FORT CALHOUN STATION, UNIT NO. 1

AMENDMENT TO FACILITY OPERATING LICENSE

Amendment No. 43
License No. DPR-40

ATTACHMENT TO LICENSE AMENDMENT NO. 43

FIGURE
2-6

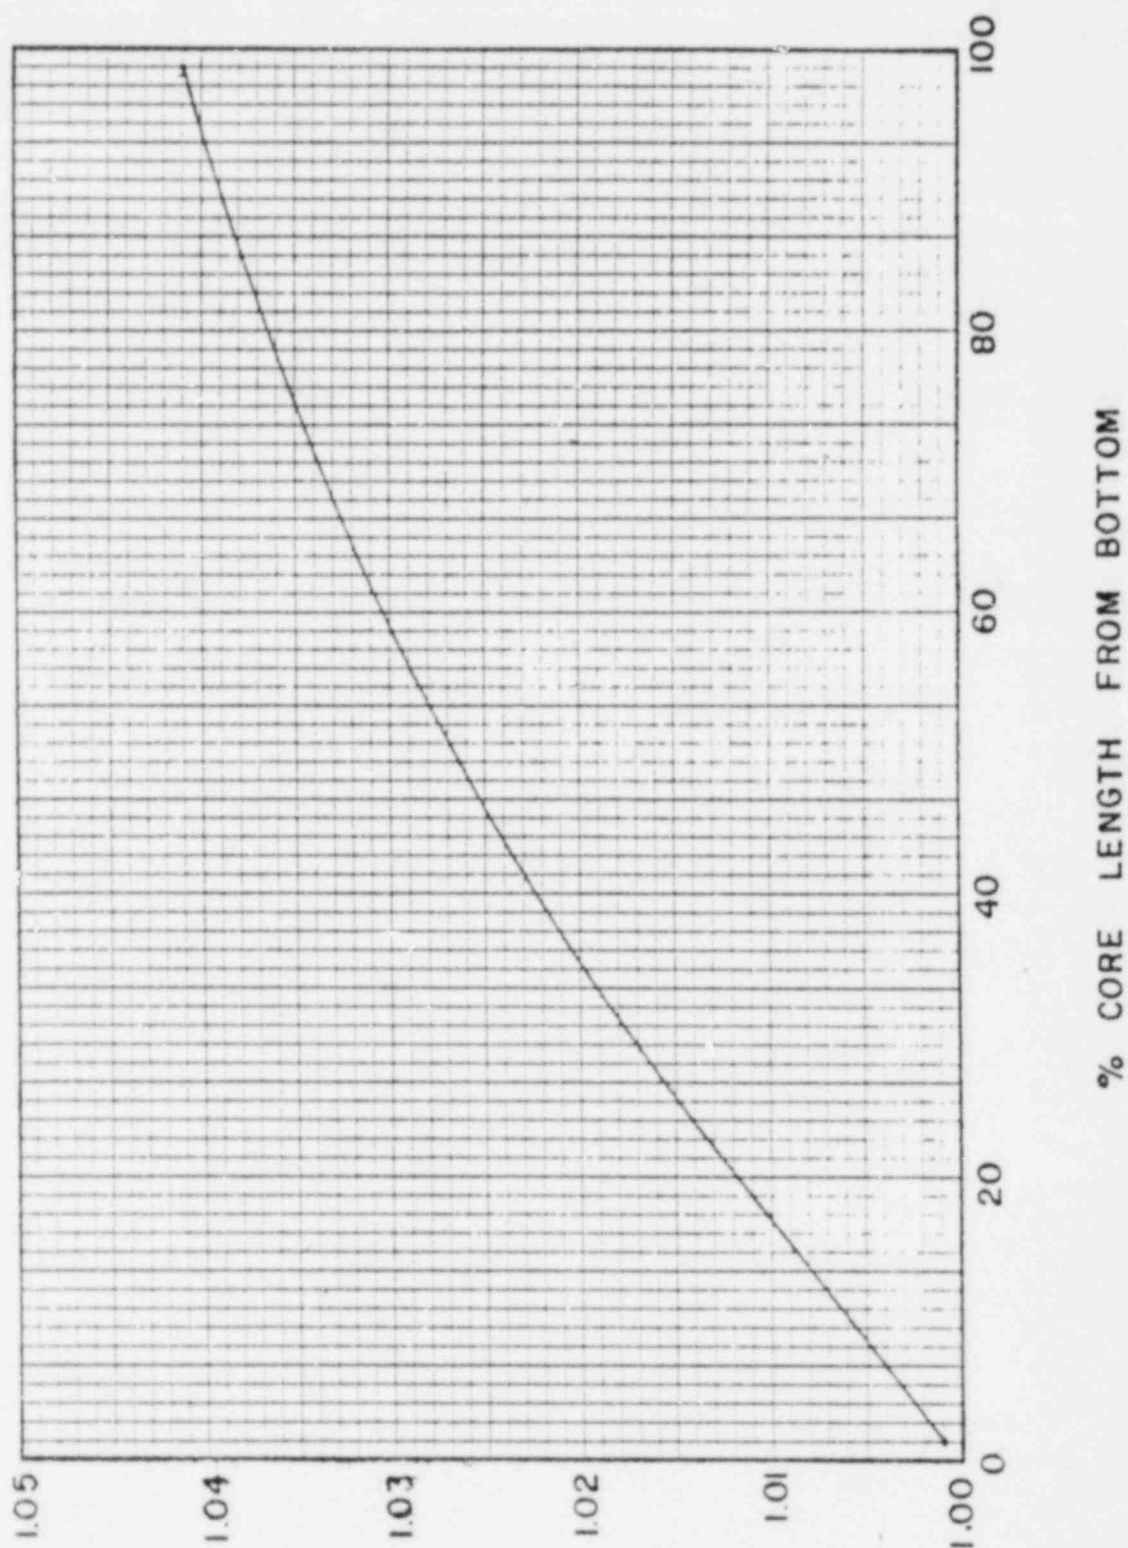
NOTE: When power is reduced to comply with (a) above, and linear heat rate is being monitored using excore detectors, Figure 2-6 must be adjusted in accordance with Specification 2.10.4.(1).(c).

- (b) Reduce the allowed power level of the axial power distribution linear heat rate monitoring limits of Figure 2-6 by the amount $2.22 \times [(F_{xy}^T/1.62)-1] \times 100$ percent of rated power, and reduce the positive and negative axial shape index trip limits of Figure 1-4 by the amount $.01 \times [(F_{xy}^T/1.62)-1] \times 100$ ASI units, withdraw the full length CEA's to or beyond the Long Term Steady State Insertion Limits of Specification 2.10.2(7) and fully withdraw the PLCEA's, or
- (c) Be in at least hot standby.
- (4) Azimuthal Power Tilt (T_q)

FIGURE
2-8

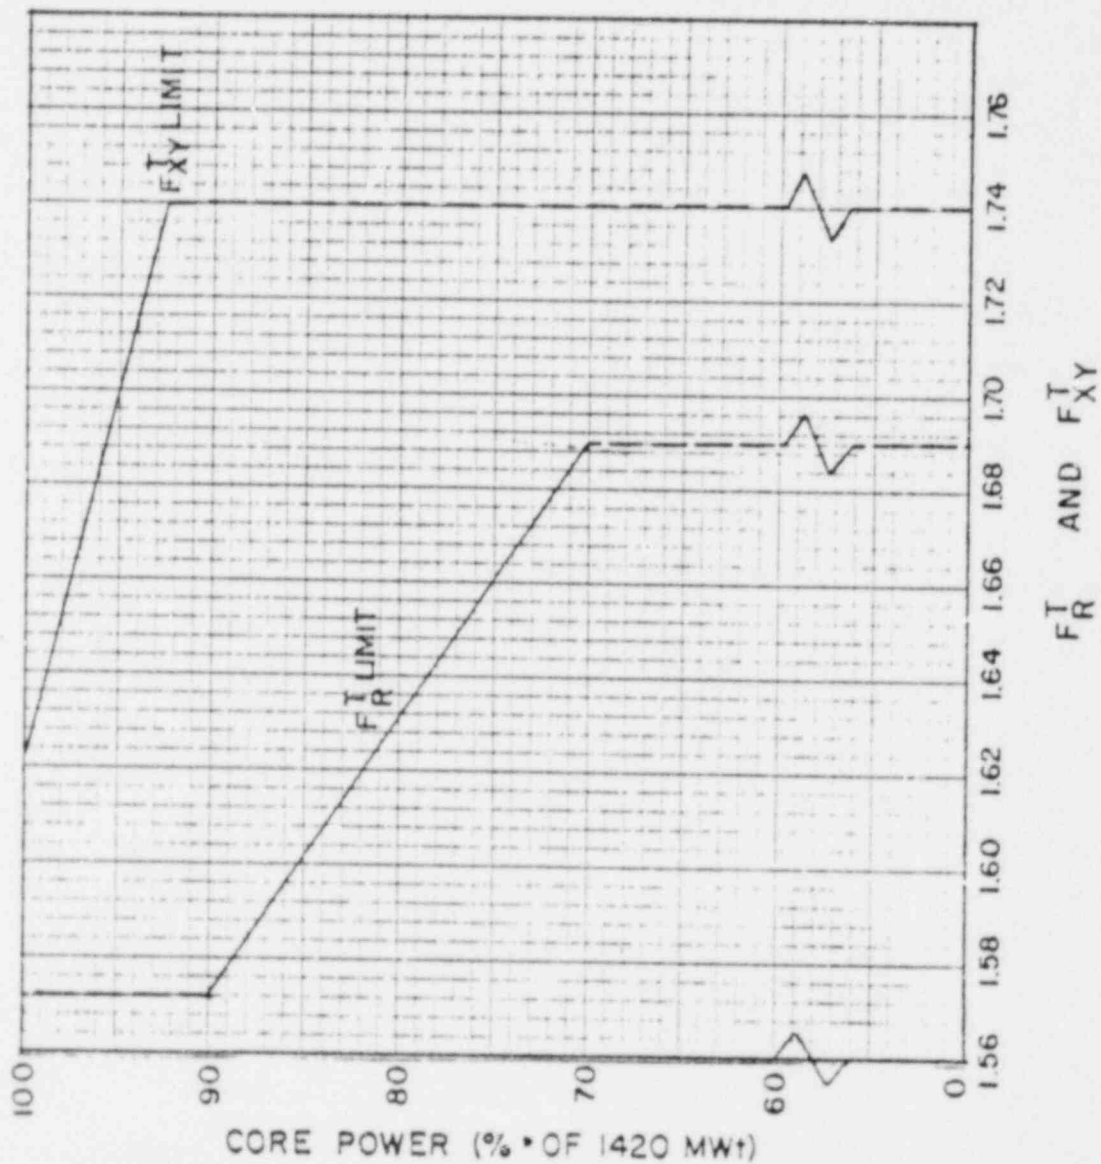
1. Flux peaking augmentation factors are shown in Figure 2-8,
2. A measurement-calculational uncertainty factor of 1.058,
3. An engineering uncertainty factor of 1.03,
4. A linear heat rate uncertainty factor of 1.002 due to axial fuel densification and thermal expansion, and
5. A power measurement uncertainty factor of 1.02.
